1 INTRODUCTION

- 1.1.1 Prime Transport Planning Ltd (Prime) have been provided with comments from Phil Palmer (Highway Development Control Engineer) at Wrexham County Borough Council (WCBC) dated 29th January 2019. These comments were made in relation to the Transport Assessment (TA) prepared in support of an outline planning application (EP/DC/P/2018/1087) for proposed commercial development located off Clywedog Road South on Wrexham Industrial Estate (WIE). The development is split over two parcels of land, each parcel having their own separate access point onto Clywedog Road South. The northern parcel of land comprises B2/B8 usage, of up to 70,000 sqft. The southern parcel of land comprising up to 27,073 sqft, of B1/B2 usage.

WREXHAM INDUSTRIAL ESTATE - SITE 5

P18045-004C

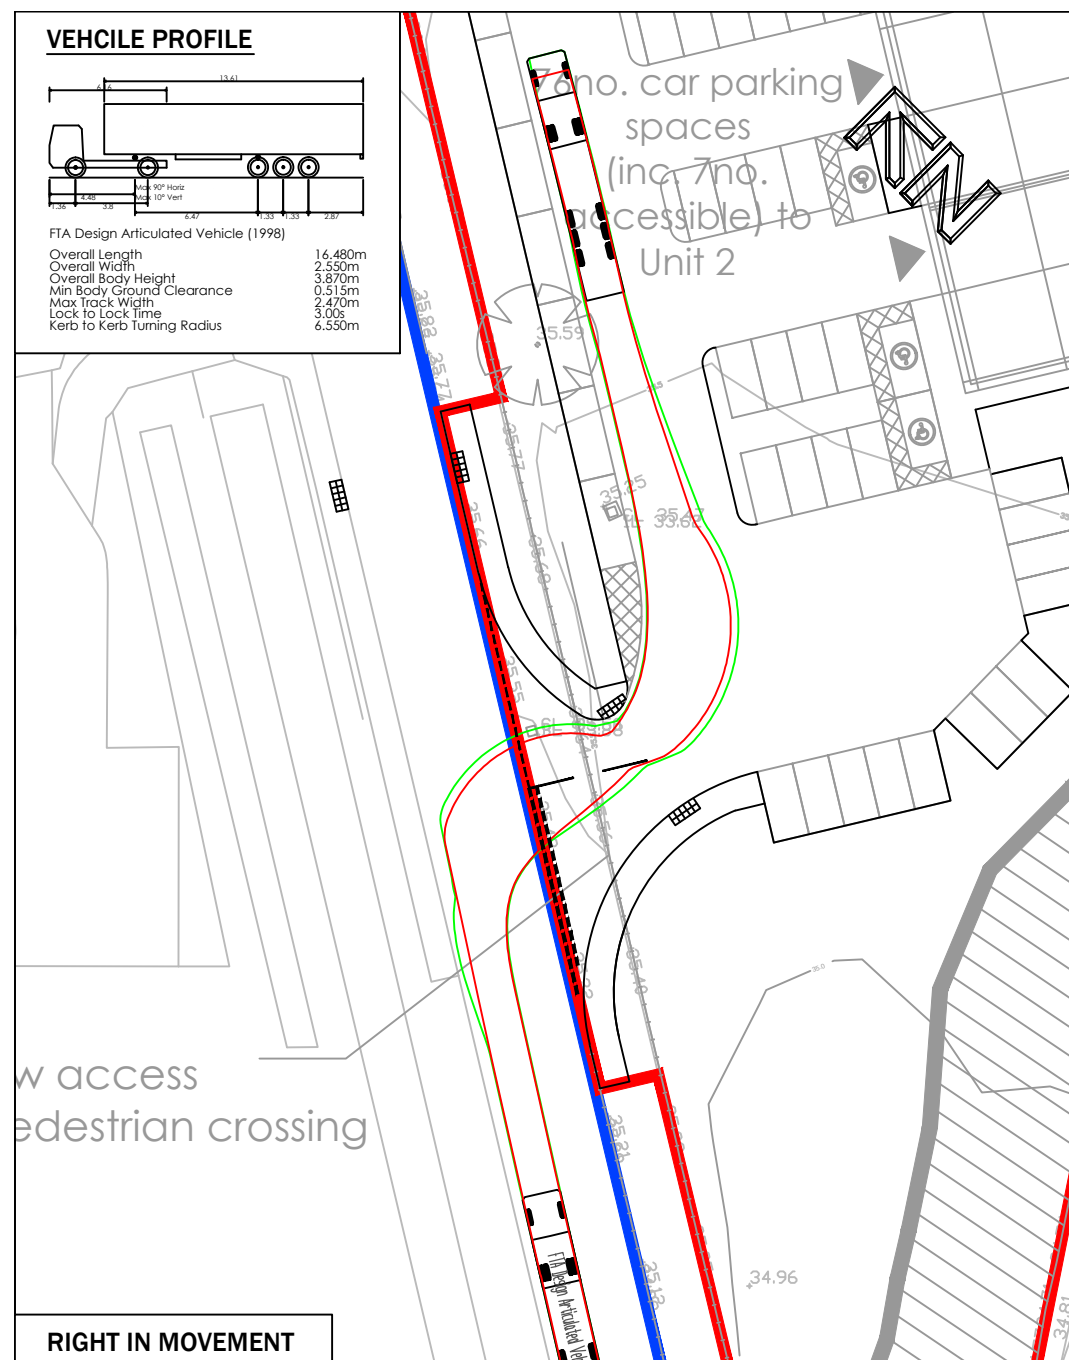
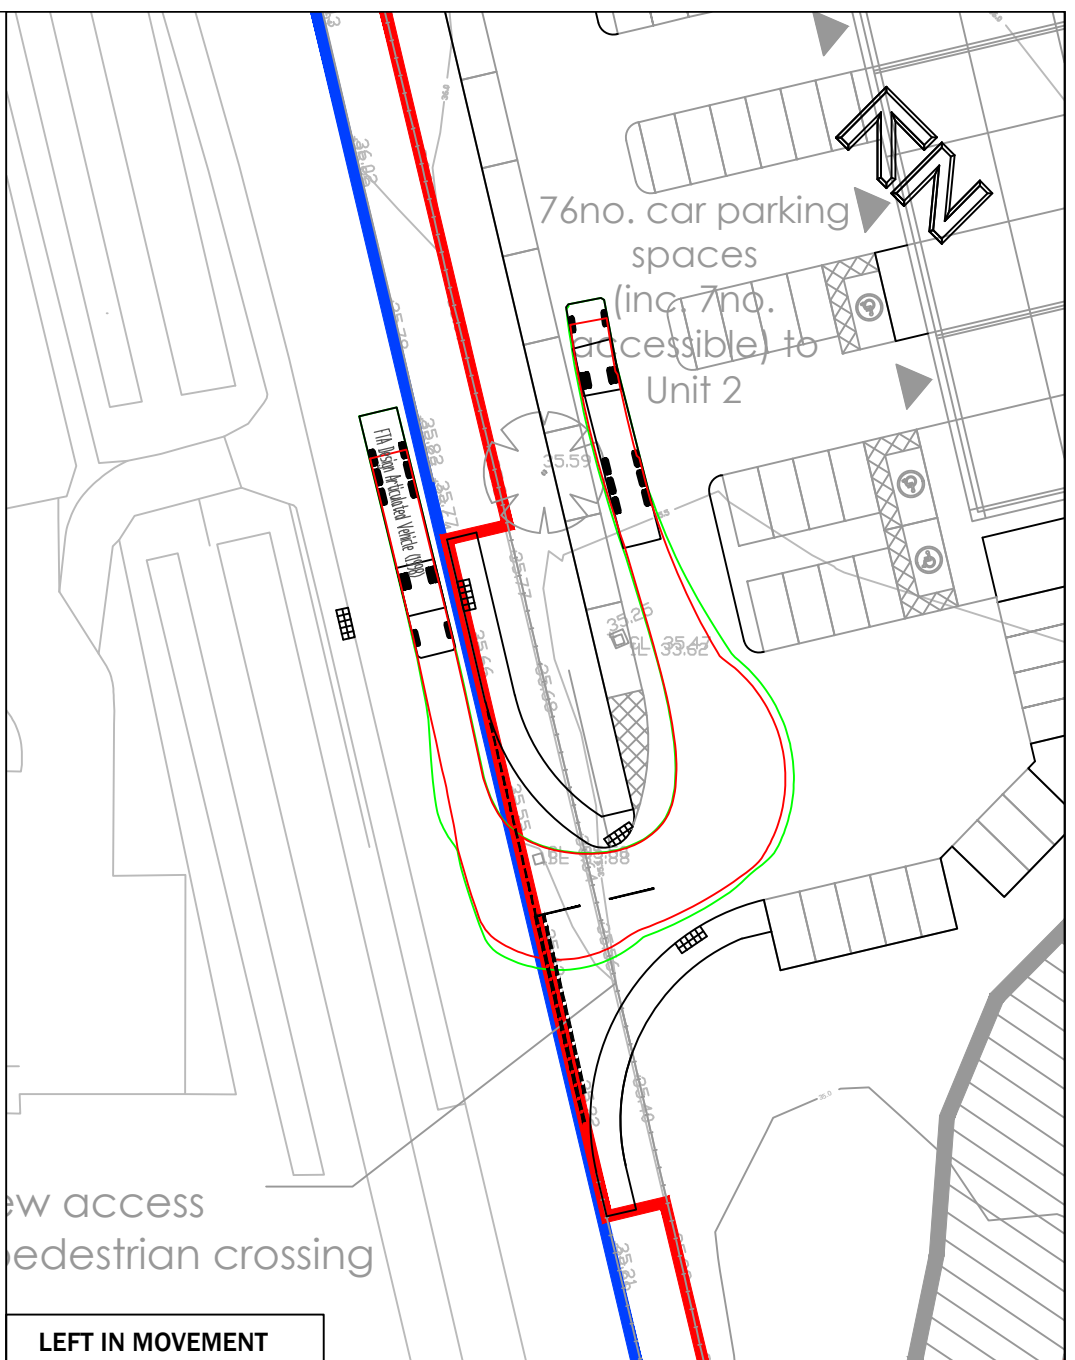
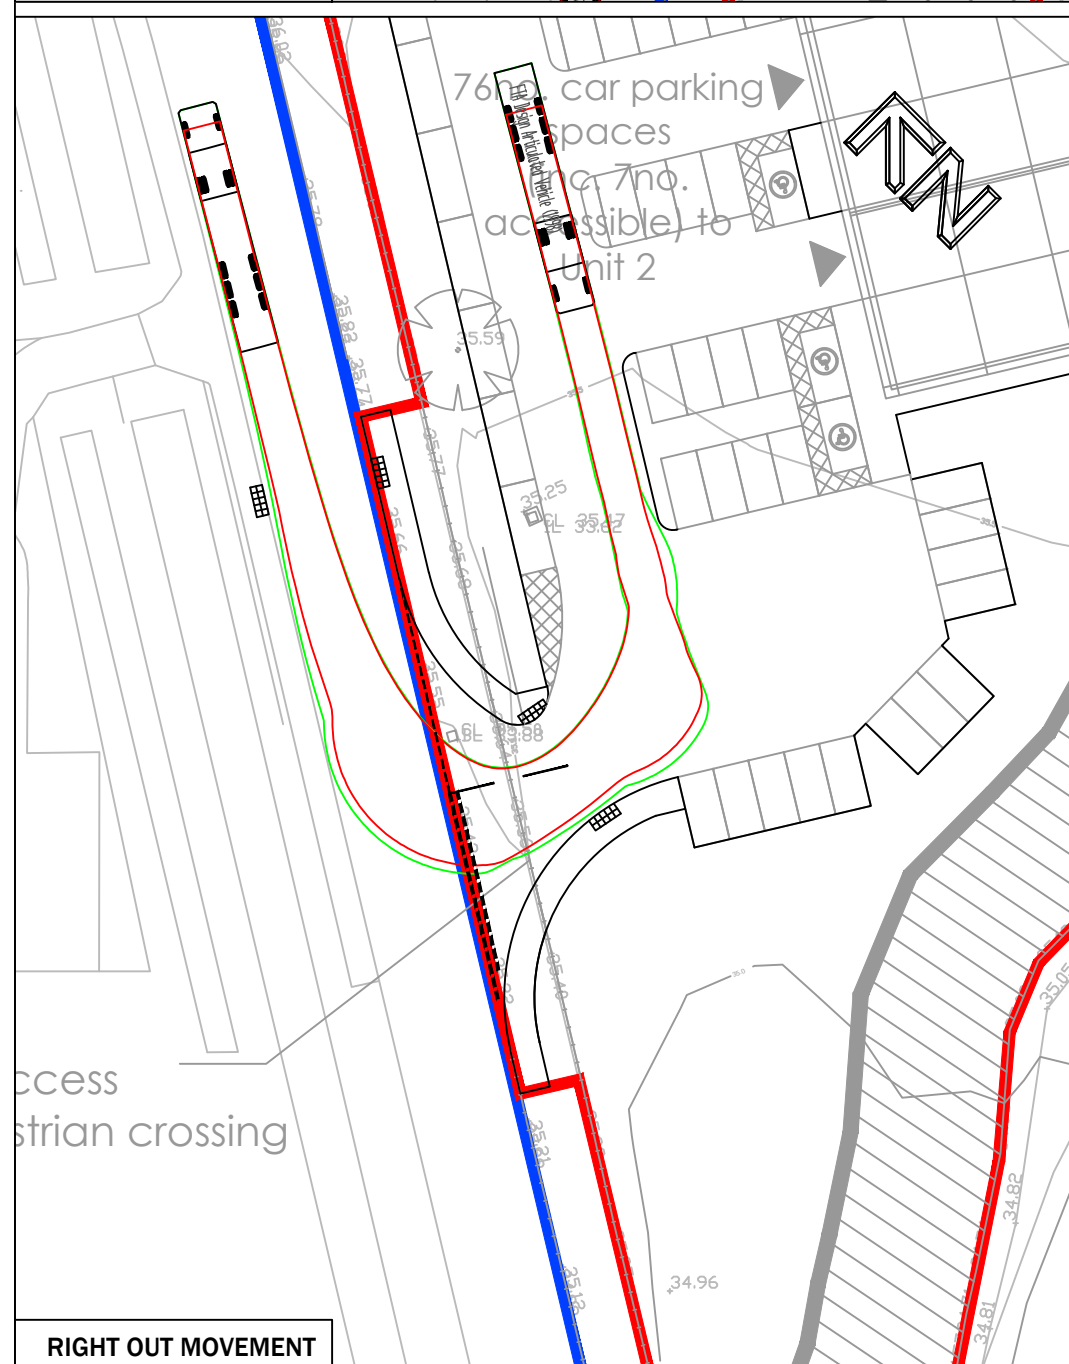
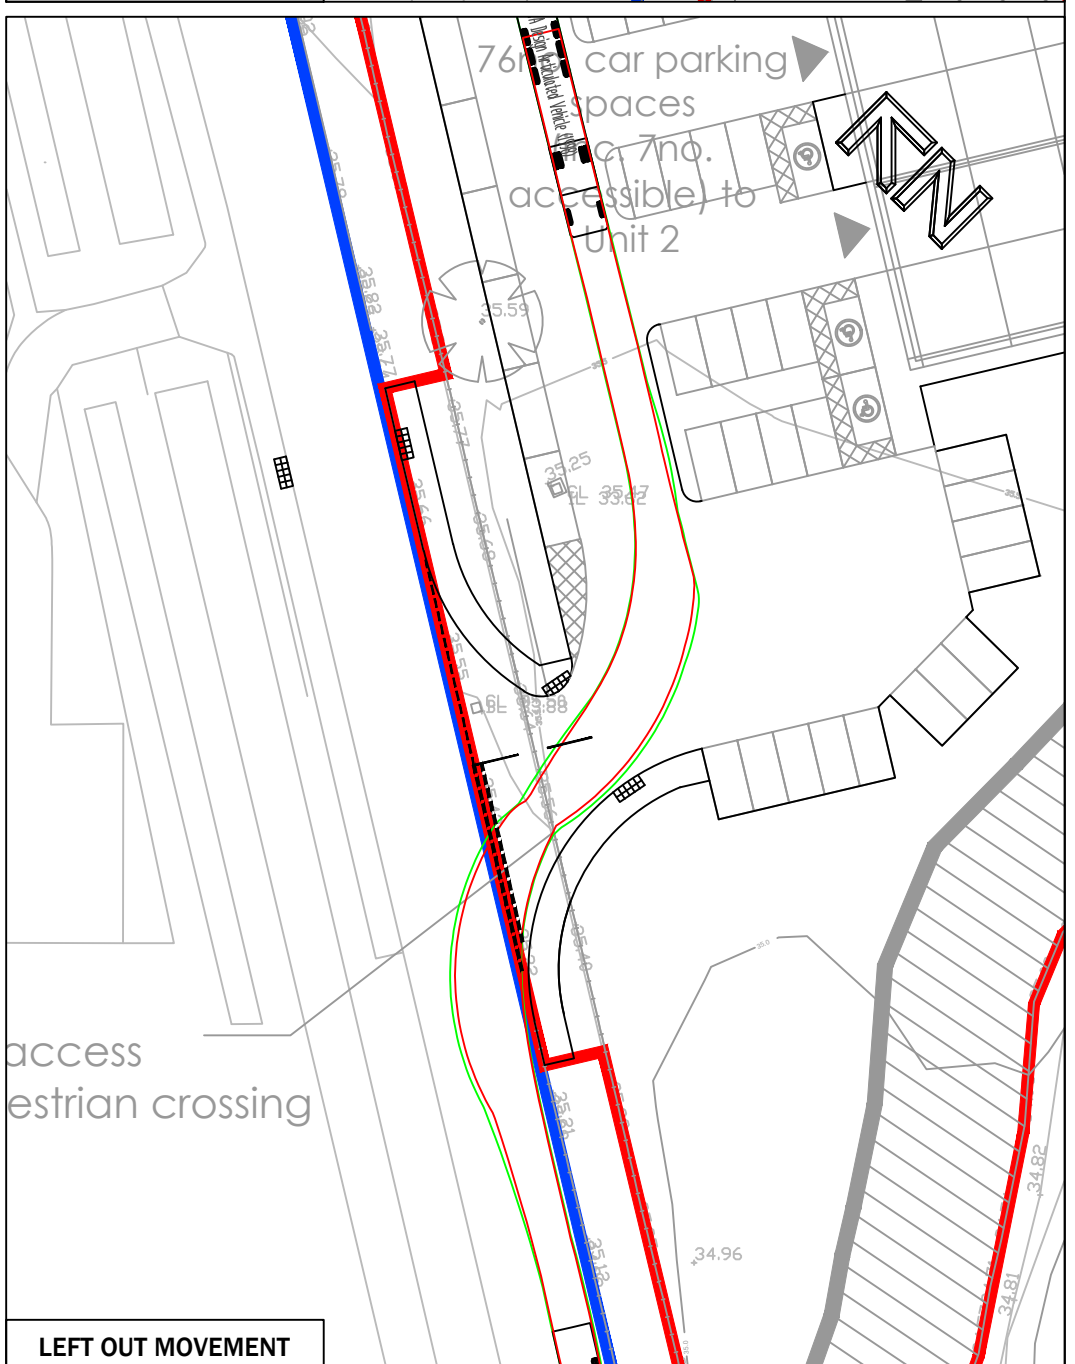
- 2.2.1 *Point 5 - The proposed access appears to be 14 wide with limited kerb radii. There would appear to be a turning facility located directly behind the access to allow 16.5m HGVs to turn. This arrangement is considered unacceptable and has the potential for conflict of vehicle movements entering/exiting the site. I would recommend that the applicant considers re-locating the access further to the north east where the site has potentially more depth to accommodate a more suitable access*

- 2.2.2 Amended access drawing **P18045-002C**, provided within **Appendix I** of this response, details the reduced access carriageway width to the site. The access can be seen to be 7.5m in width with 15m radii. Drawing **P18045-004C** contained within **Appendix I** demonstrates that a 16.5m articulated lorry can still access and egress the site via this amended access point. The turning facility located directly behind the access has been removed in line with WCBC comments, vehicles turning within the site can still be accommodated within the turning circle shown toward the northern part of this site.
